SUBMITTAL IDENTIFICATION SHEET

WEBSTER UNIVERSITY ISB
PROJECT NAME

PROJECT: 15051-Webster University Interdisciplinary Science Building

RE: East Rail and Bollard Shop Drawings

PARTIAL EAST RAIL PLAN

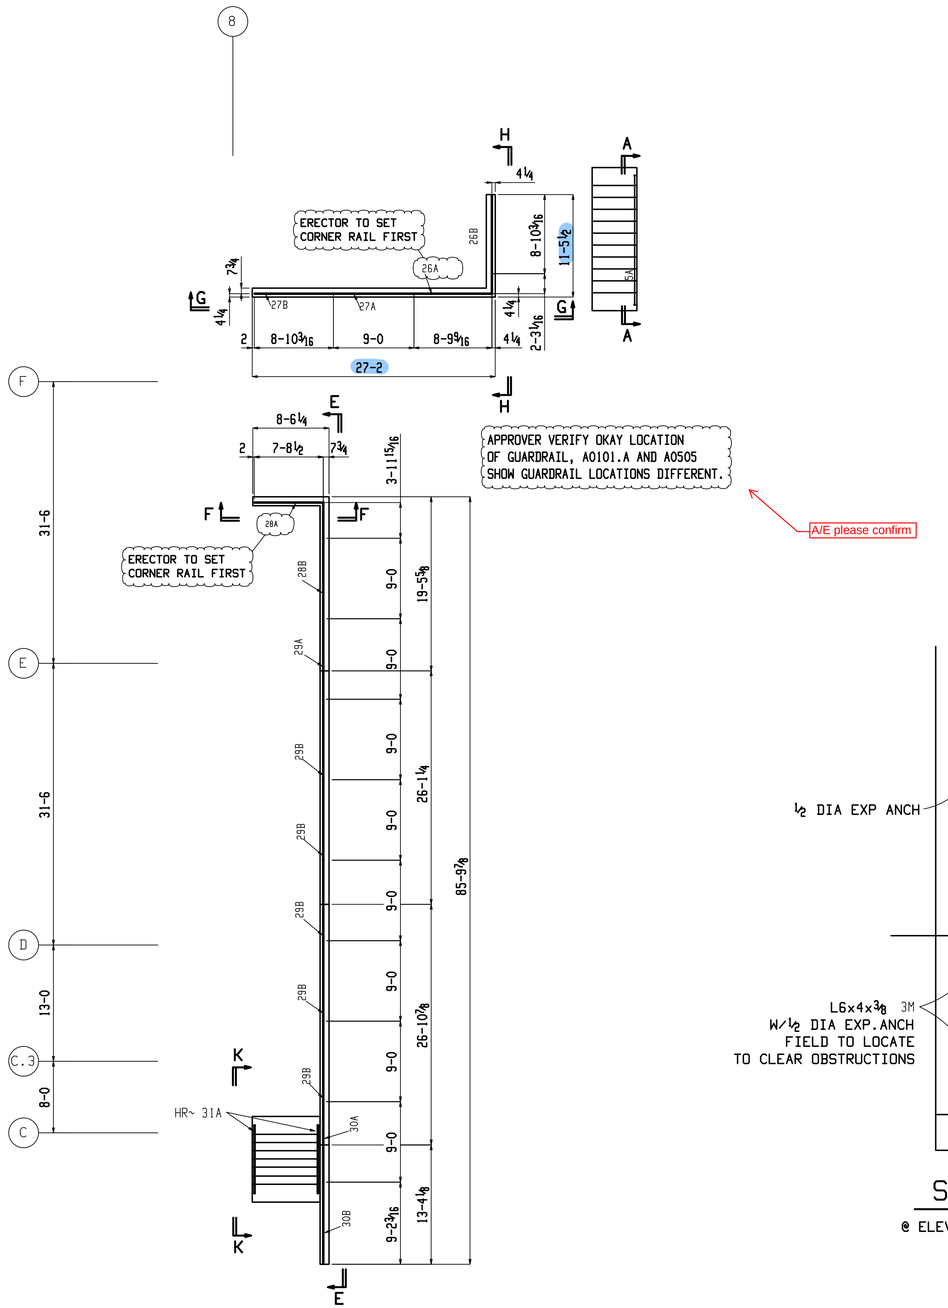
APPROVER VERIFY OKAY LOCATION OF GUARDRAIL, A0101.A AND A0505 SHOW GUARDRAIL LOCATIONS DIFFERENT.

A/E please confirm

SECTION K-K

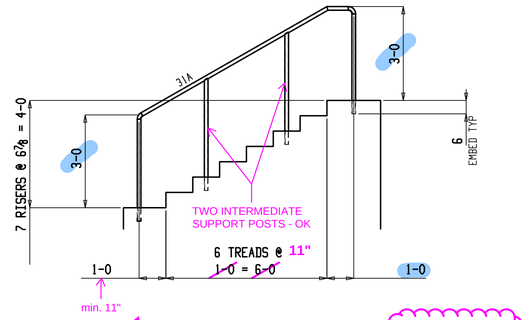
REVISE PER RFI-370

ONE GUARDRAIL 26A

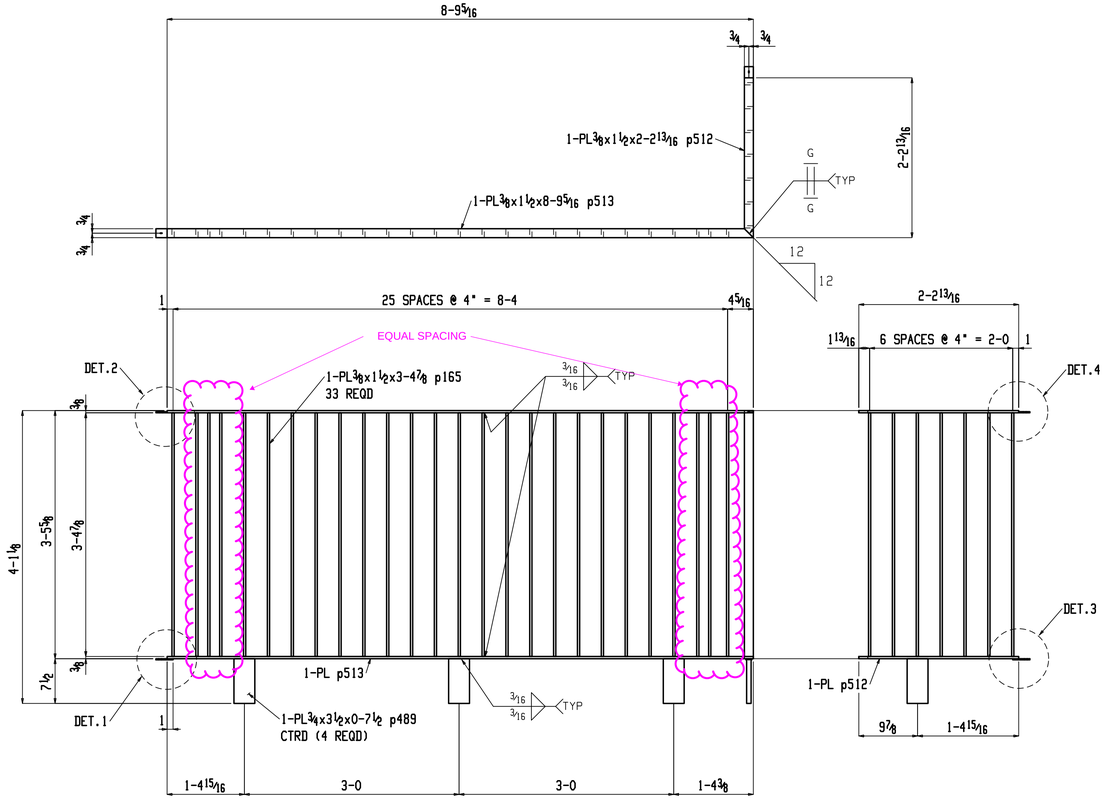
Provide product data.
Color to match
curtainwall mullions.

ONE GUARDRAIL 27A

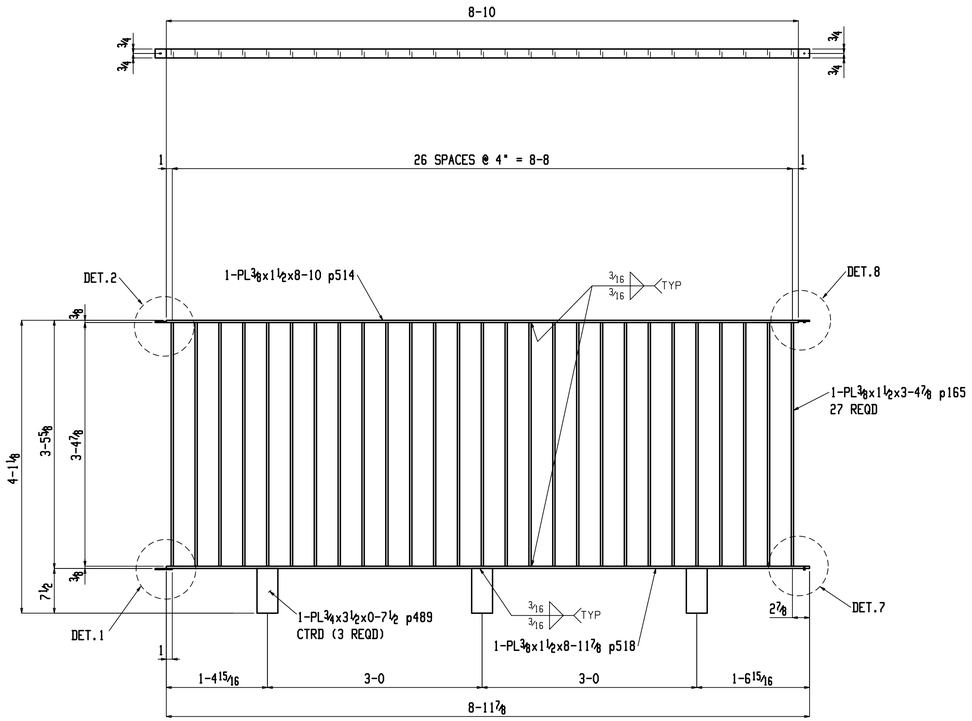
Provide product data.
Color to match
curtainwall mullions.

ONE GUARDRAIL 28A

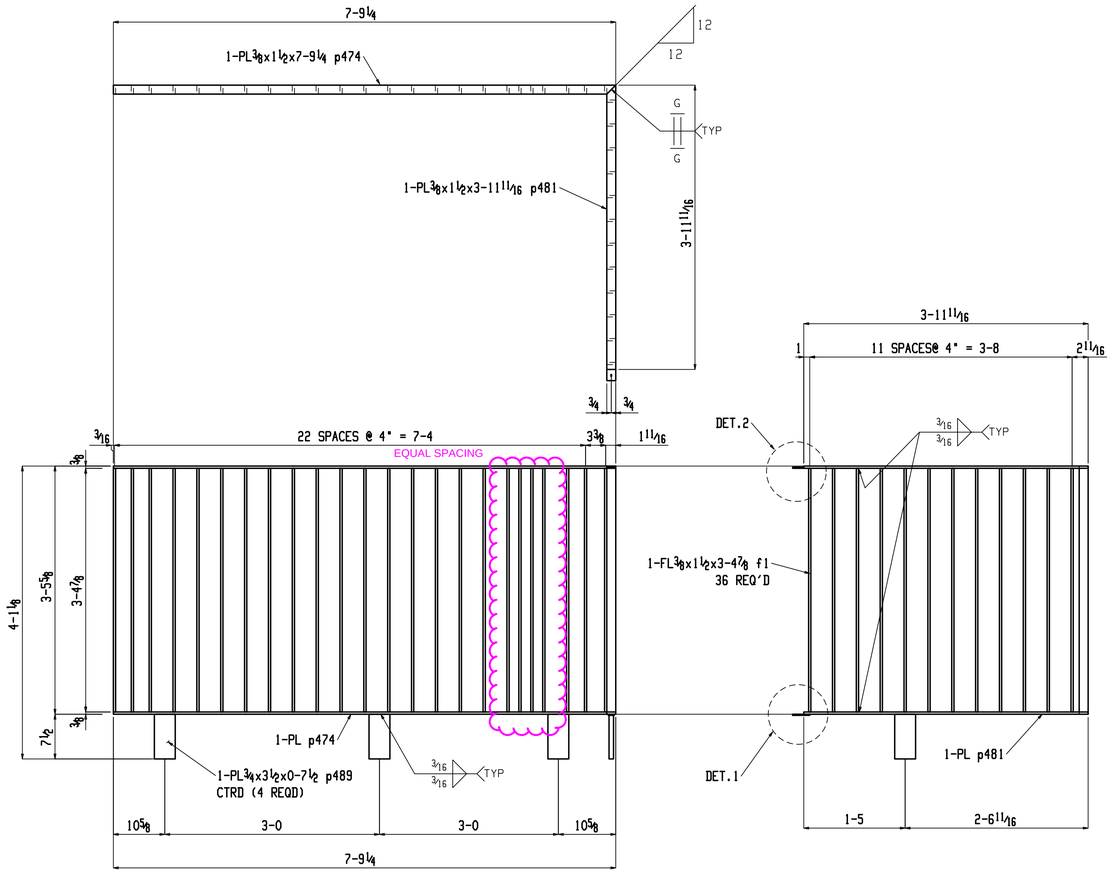
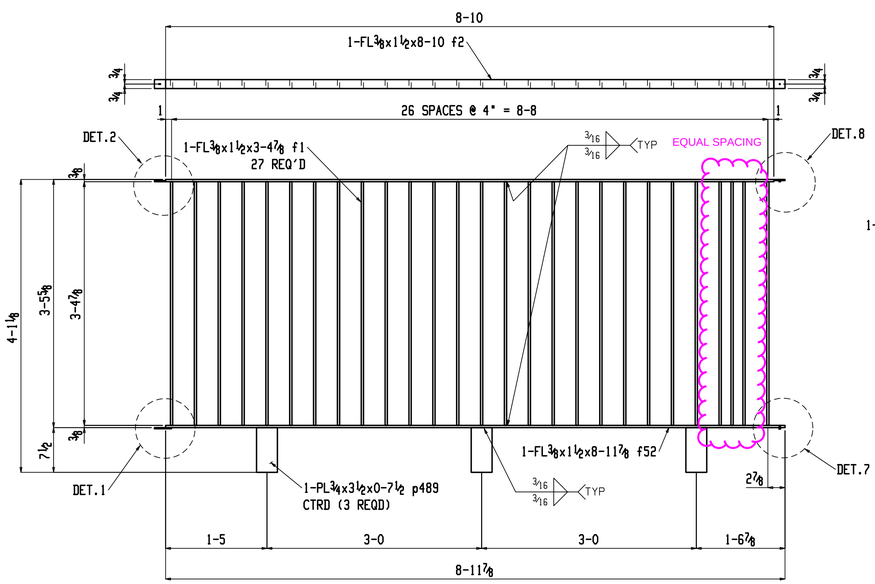
Provide product data. Color to match curtainwall mullions.

ONE GUARDRAIL 29A

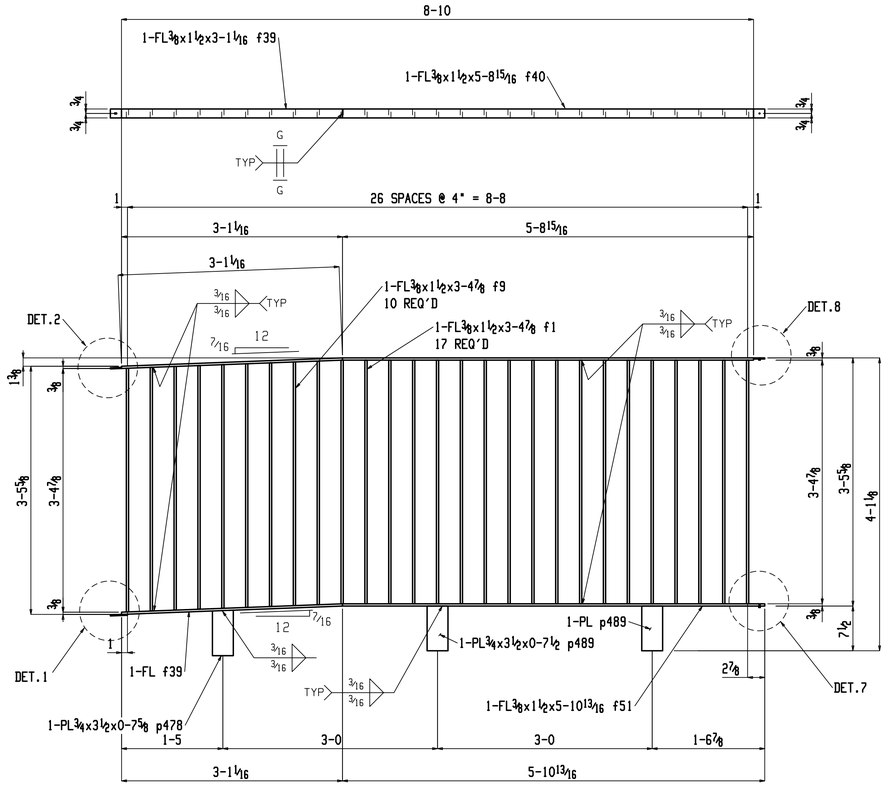
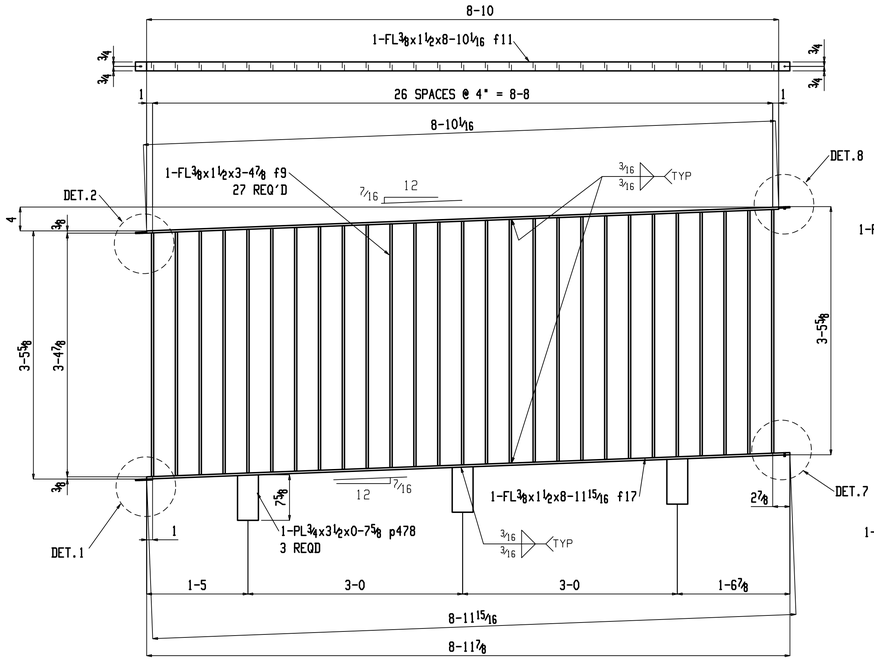
Provide product data.
Color to match
curtainwall mullions.

ONE GUARDRAIL 30A

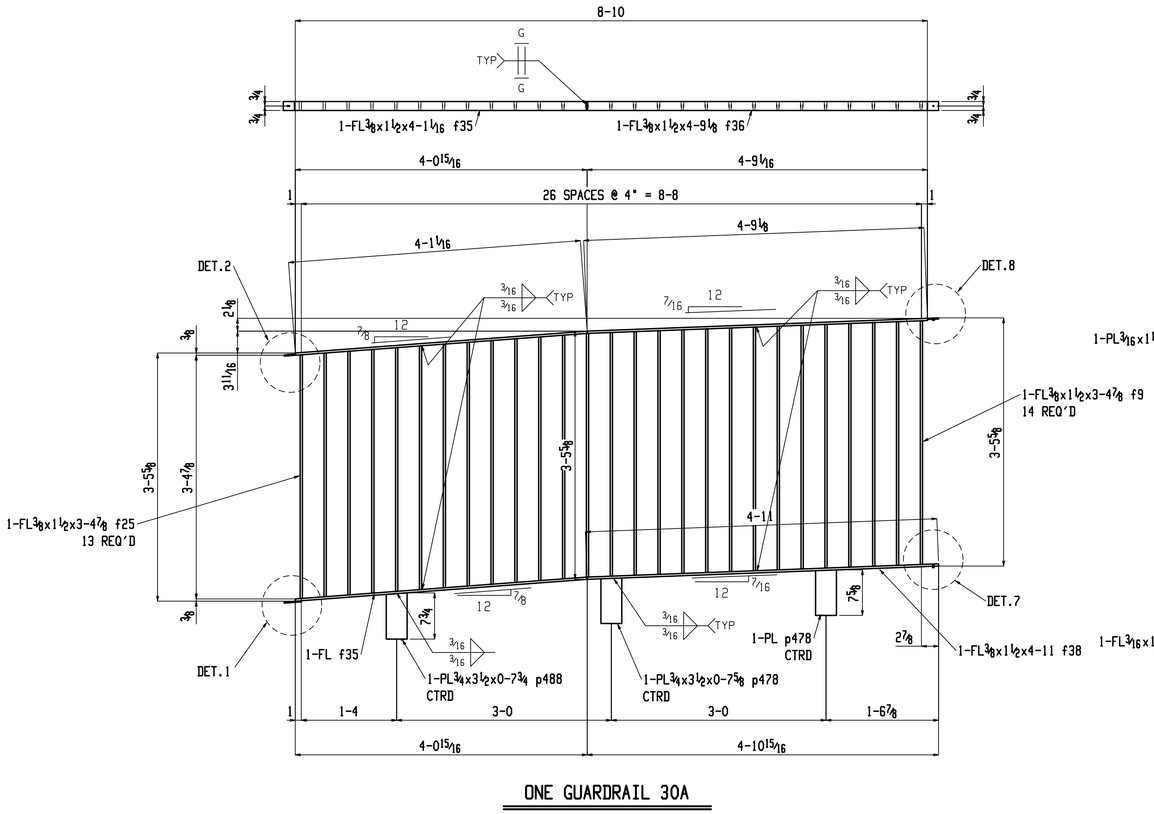
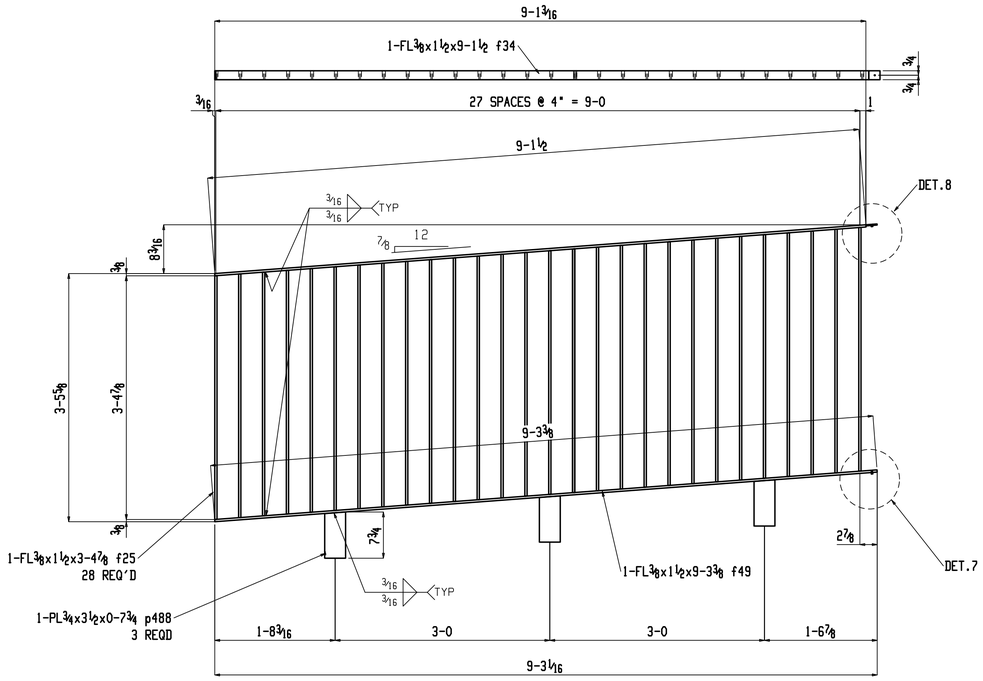
Provide product data.
Color to match
curtainwall mullions.

2 HANDRAILS 31A

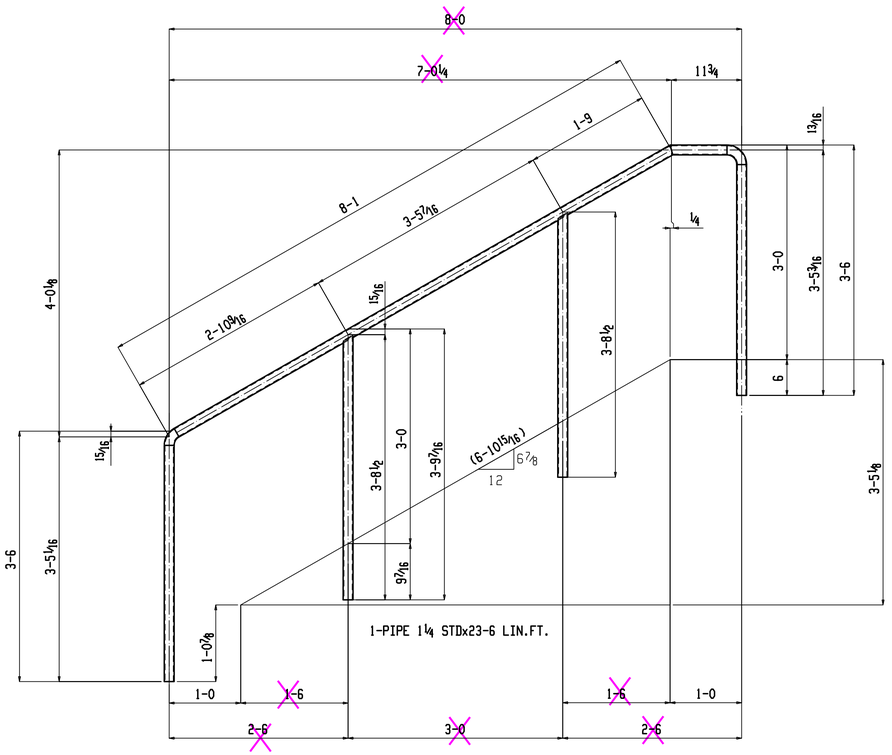
REVISE PER COMMENTS ON DWG# E1

Provide product data. Color to match curtainwall mullions.

20 BOLLARDS 32A

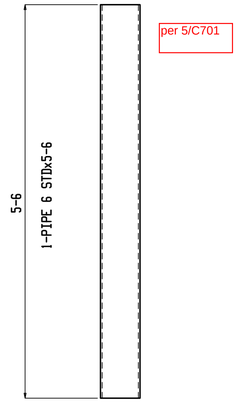
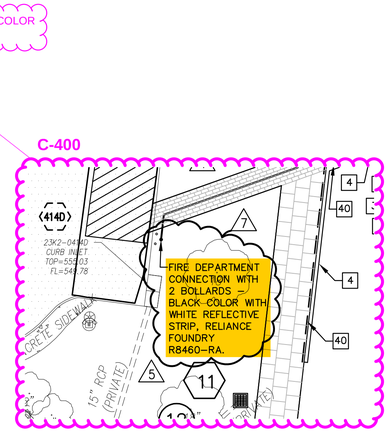
VERIFY

ACCEPTABLE FOR BOLLARD TYPE 32A ON EAST SIDE OF BUILDING.
